SUGARLOAF INTERCONNECTOR PIPELINE

PROJECT IMPACT ASSESSMENT REPORT

REPORT OF THE ADVISORY COMMITTEE

16 May 2008

Figure 1: Preferred "Blue Line" Pipeline Alignment

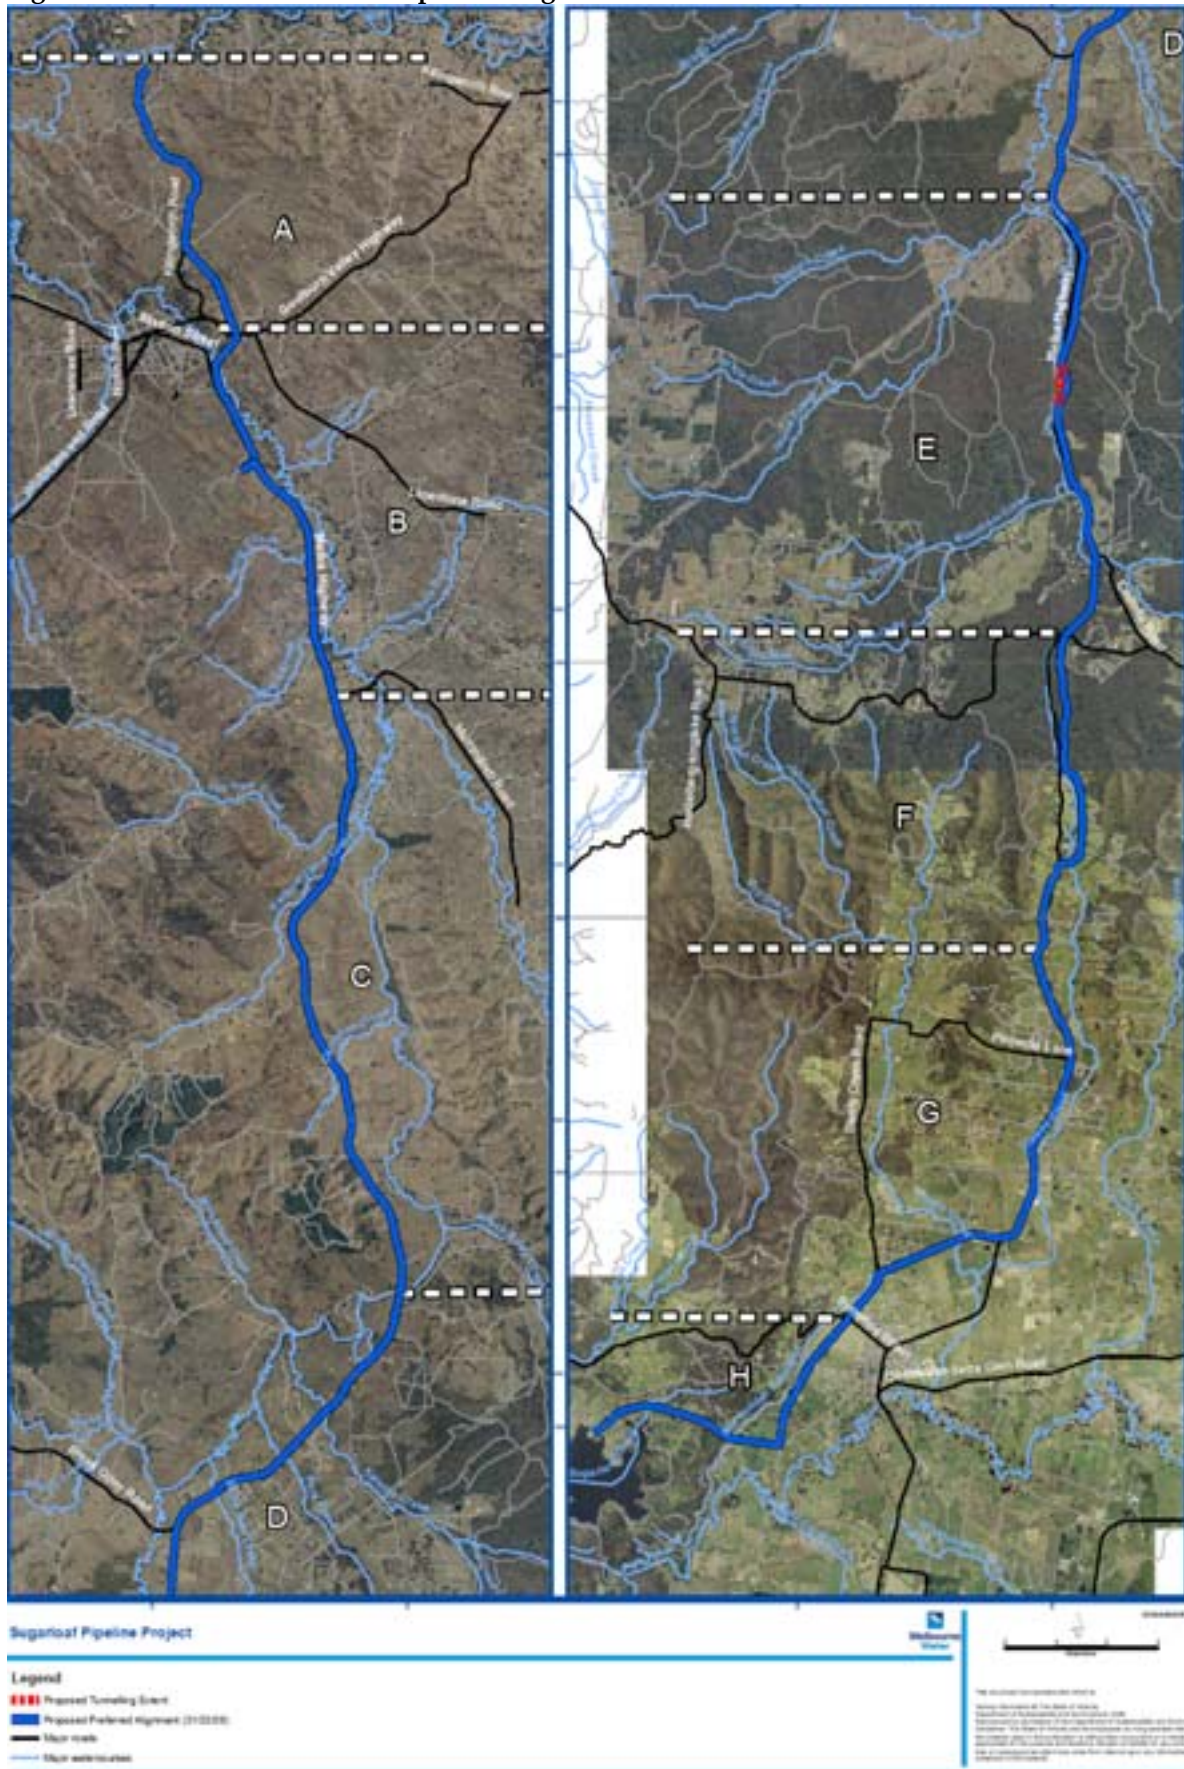
Notwithstanding the foregoing discussion, the preferred pipeline route as shown as Figure 1 is acceptable, subject to minor realignment as agreed with the individual landholders affected by the preferred route. Such realignment as may be agreed is likely to be to protect environmental and social (land productivity and business) issues which arise and which are within the flexibility of the pipeline for minor realignment which is advised as being between 1 and 3 degrees.

Figure 2: Suggested Environmental Management Framework

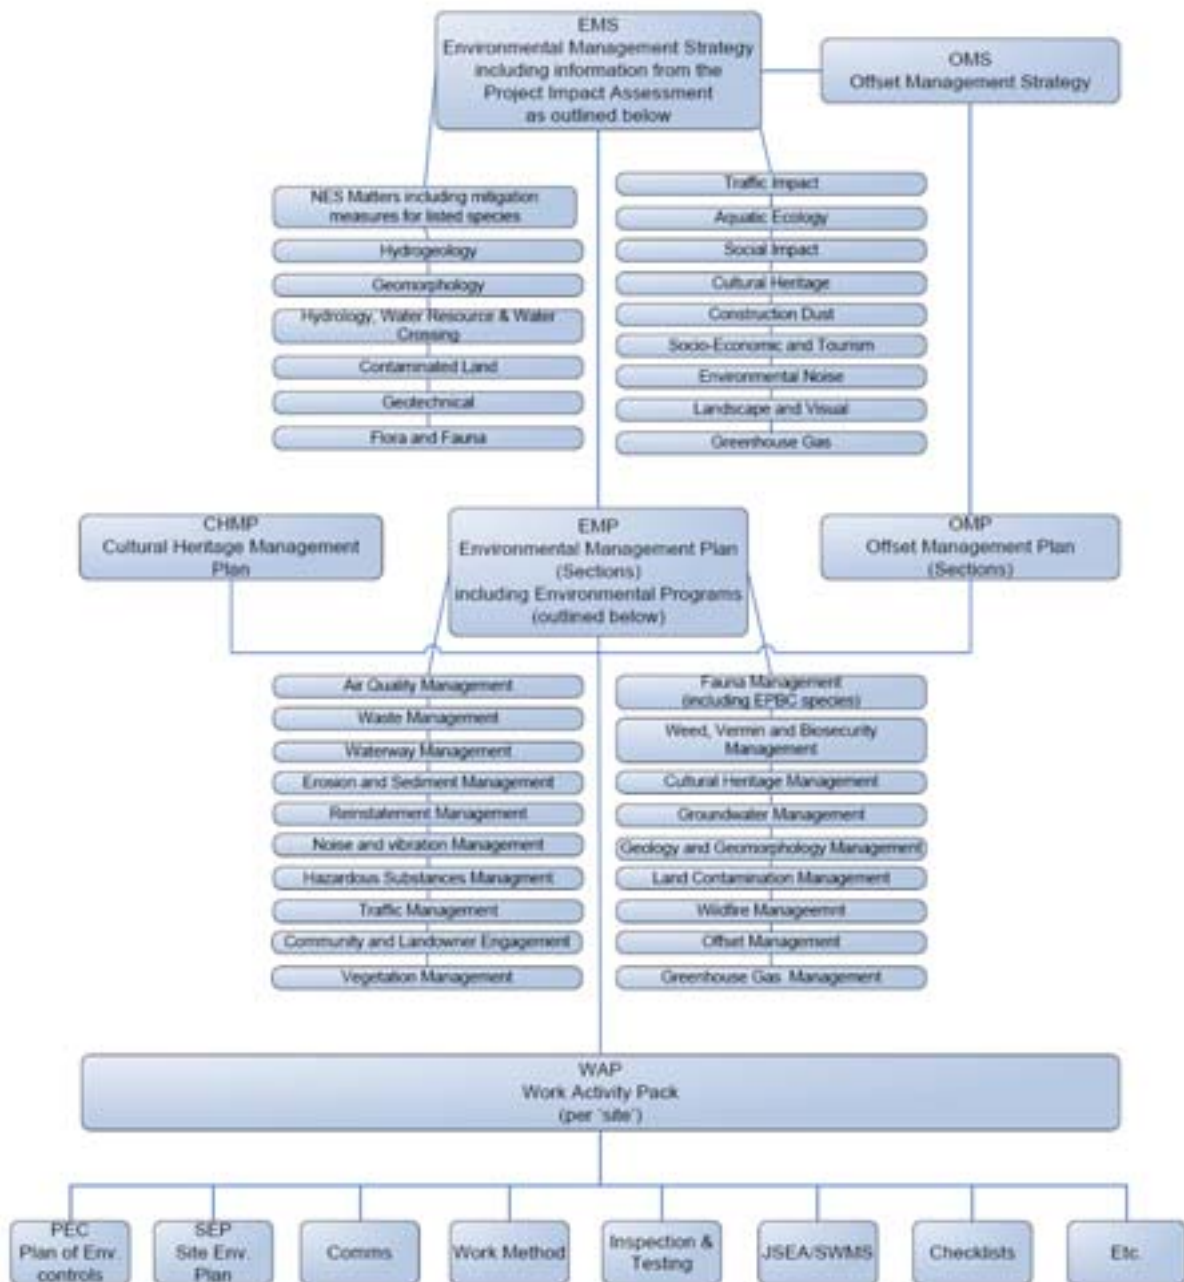
The Committee considers in general that the environmental management framework for the project is sound. The key elements of this are an Environmental Management Strategy (EMS) for the whole project, Environmental Management Plans (EMP) for specific sections and Work Activity Packs (WAP) for particular sites requiring a high level of environmental management. In the hearing the Alliance tabled a draft EMS, a draft example EMP and a draft example WAP (Matted Flax Lily on Gulf Road).

An updated project environmental management framework was provided by the Alliance with correspondence dated 7 May 2008. This updated structure is provided in Figure 2. In the draft EMS tabled at the hearing, an earlier version of the structure was provided (at page 9) and this indicated that at the EMS level, the Minister for Planning would sign off on the document; at the EMP level DSE/DPCD would be responsible for approval; and at the WAP level the Alliance itself would sign it off.
